TITLE	HF RECEIVER FRONT PCB
MODEL	HF3-04
REFERENCE	SCHEMATIC DIAGRAM
ISSUE No	001

TITLE	HF RECEIVER
MODEL	HF3-04
REFERENCE	BLOCK DIAGRAM
ISSUE No	001

APPENDUM TO GUIDE: HEADPHONE SOCKET & MICROPROCESSOR RESET

HEADPHONE SOCKET

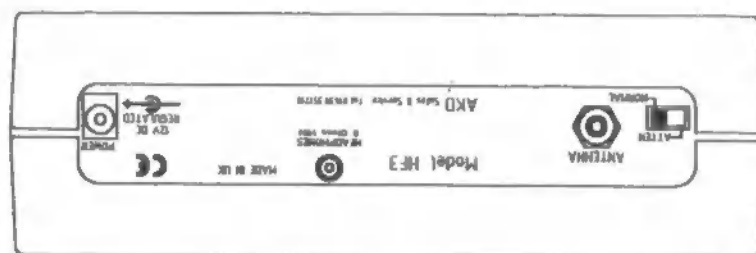
The above supersedes the paragraph on page 12, "The HF3 has no facility for external audio output"

impedance of the accessory being used. If unsure ring for advice.

in use. The impedance is 8 Ω minimum. Do not plug into this socket without establishing the panel as shown in the drawing above. This socket is a 3.5mm type and the speaker is muted when

The **TARGET HF3** Receiver manufactured by **AKD** has a headphone socket mounted on the rear
